INDESIT company

Model type:
LSP720AB

Commercial code:
F068896

n4513g02: INTRODUCTION OF NEW SYNCHRONOUS MOTOR

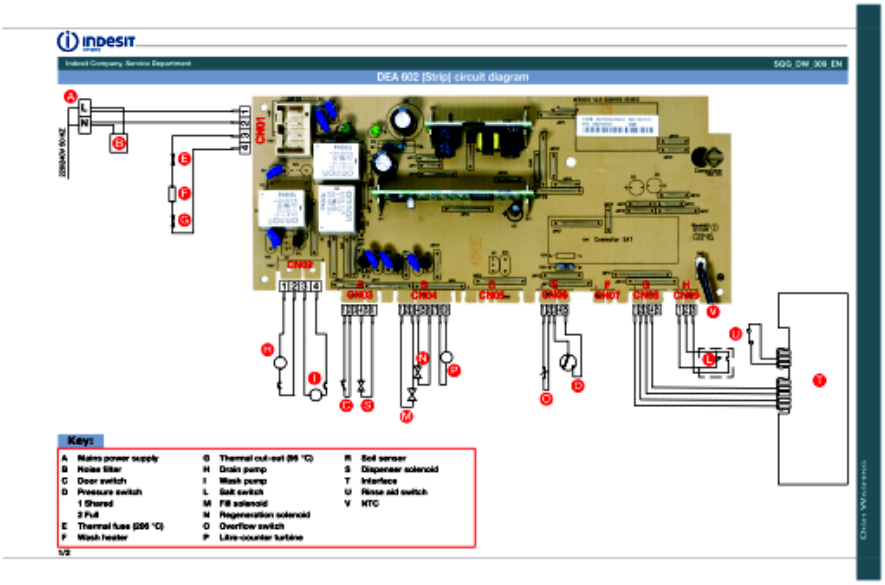
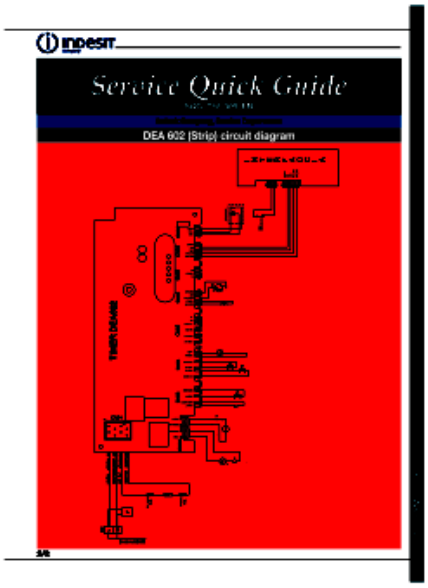
A new electropump has been introduced in the synchronous motor. This is perfectly interchangeable with the previous one, only the dowel has been modified improving its quality.

New motors have new codes:

Old New
C00256523 -> C00302800
C00256525 -> C00302798
C00272798 -> C00302796
